**Re: FortisBC Energy Inc. (FEI)**

**Project No. 1599211**

**Application for a Certificate of Public Convenience and Necessity (CPCN) for Approval of the Advanced Metering Infrastructure (AMI) Project (Application)**

**Response to Coalition to Reduce Electropollution (CORE) Information Request (IR) No. 3 on Rebuttal Evidence**

12             Figure 3.     Blackbody image of a human holding a toy metal gun (a)  
 13                         photograph, (b) image in the RF/microwave portion of the  
 14                         electromagnetic spectrum. (Meng et al., 2018).

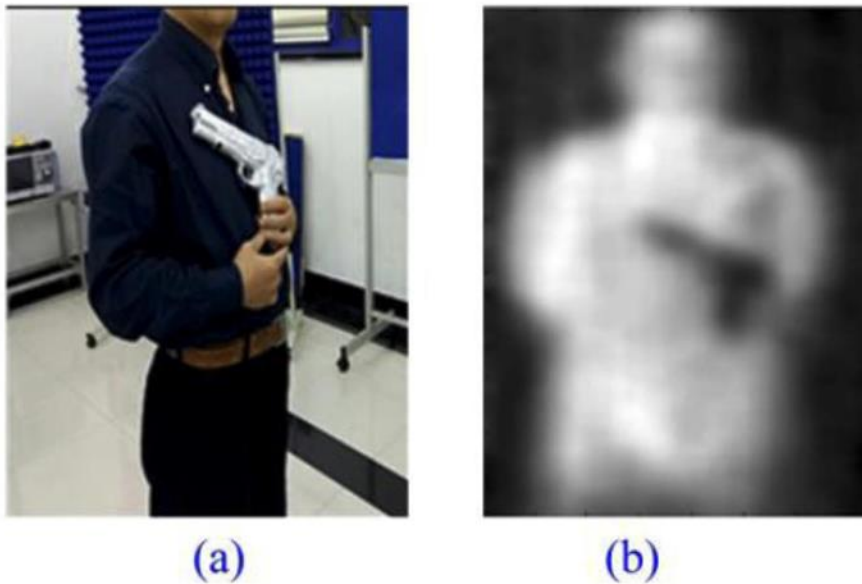
2             **Reference:   FEI Rebuttal Evidence, Exhibit B-26**  
 3                         **PDF page 65-66, Section 5.1 (Comparisons to Blackbody Radiation),**  
 4                         **Q 25, Figure 3.**

5             Issue: On PDF pages 65-66 (lines 1-5), Exponent provides the following response to Q25  
 6             and commentary regarding Figure 3:

7                         Although extremely small, the blackbody energy from humans can be measured  
 8                         with the use of proper instrumentation. For example, the RF/microwave energy of  
 9                         a human is shown below in Figure 3. The image is an example of the RF energy  
 10                        from a human in the RF/microwave portion of the electromagnetic spectrum and is  
 11                        proposed to be used in security applications.

15             9.a     Please confirm that the caption provided with Figure 3 is its original caption. If not,  
 16             please provide the original caption.

19             The caption for Figure 3 was added by Exponent to assist the lay reader in understanding the  
 20             context. The original caption read “Figure 12. A Volunteer Holding a Metal Toy Gun. (a) Photo of  
 Real Scenario, (b) Imaging Result.”

12            Figure 3.    Blackbody image of a human holding a toy metal gun (a)  
 13                            photograph, (b) image in the RF/microwave portion of the  
 14                            electromagnetic spectrum. (Meng et al., 2018).

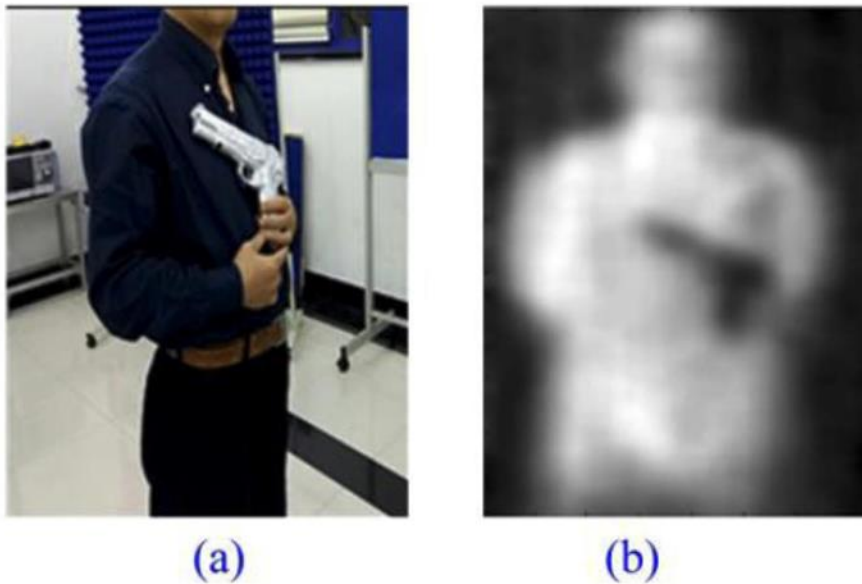
2            **Reference:    FEI Rebuttal Evidence, Exhibit B-26**  
 3                            **PDF page 65-66, Section 5.1 (Comparisons to Blackbody Radiation),**  
 4                            **Q 25, Figure 3.**

5            Issue: On PDF pages 65-66 (lines 1-5), Exponent provides the following response to Q25  
 6            and commentary regarding Figure 3:

15            10.a    What evidence does FEI rely upon to support its contention that Figure 3 shows  
 16                            the measurements of RF/microwave radiation rather than thermal effects from  
 17                            passive millimeter wave (PMMW)?

10.c Why was the caption in Figure 3 changed to include RF/microwave portion of the  
electromagnetic spectrum when neither term is used in this report except to refer  
to a microwave absorbing wall?

20            Exponent disagrees with the implication that Figure 3 in the Exponent Rebuttal Evidence (Exhibit  
 B-26, Appendix B, A25, p. 30) does not show “measurements of RF/microwave radiation.” Figure

24 The description added to Figure 3 in the FEI Rebuttal Evidence was made to assist a lay reader  
25 not familiar with the definitions and terms in the highly technical paper by Meng et al. (2018)  
26 published in *Nature Scientific Reports*. Nevertheless, it is clear from the paper that the energy  
27 measured and described in the paper falls within the RF/microwave portion of the electromagnetic  
28 spectrum (i.e., 3 kHz to 300 GHz).

12 The description added to Figure 3 in the FEI Rebuttal Evidence was made to assist a lay reader  
13 not familiar with the definitions and terms in a highly technical Nature Scientific Reports paper.  
14 Please also refer to the response to CORE IR3 10.b, above.
